GOVERNMENT OF MADRAS.  
PUBLIC WORKS DEPARTMENT.

G.O., No. 413 W., 16h February 1893.

Residence for Assistant Superintendent of Police.

Circulating, with remarks, the plan for constructing a —

The plan appended is the upper storey design submitted by the C.E. with his letter No 1527 d/23 Sep. 92.

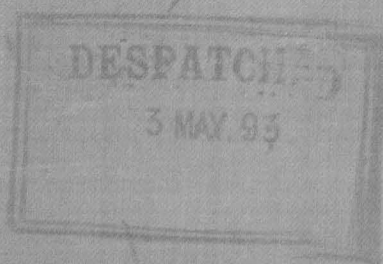
The plan will not be regarded as a standard, but will be circulated for adoption in all cases in which the estimated cost of the building is not more than Rs. 5,970.

2. To keep the estimate within this limit, brick in clay may be used for the superstructure walls, mortar being substituted for clay for 9" round doors and windows and for 1' at the top of the walls. Stabling may be provided for two instead of three horses.

A further reduction has been made by omitting one still from the out-house. The amount of the estimate will now stand as follows:—

Stabling may be  
provided for  
2 instead of  
3 horses.
